To: All Plan Holders  
From: Access Engineering, LLC  
Date of Issue: April 2, 2014  
Project: Rehabilitation of the Holloway Culvert - Addendum #2  
Project Number: BRM-5401 (679)

**SUMMARY OF QUANTITIES BRM-5401 (679)-REHABILITATION OF THE HOLLOWAY CULVERT - ADDENDUM #2**

CONCRETE REMOVAL/REPAIR  
 AT WALL CORNER - SECTION

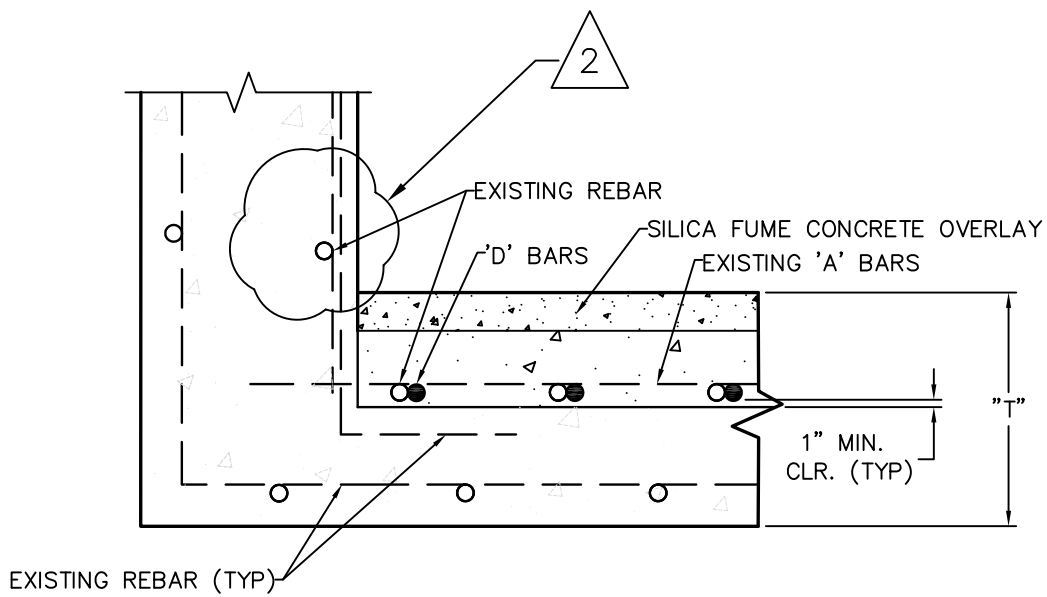
1. *Revise Detail B/D-1 to eliminate wall saw cut and patching (See attached drawing).*
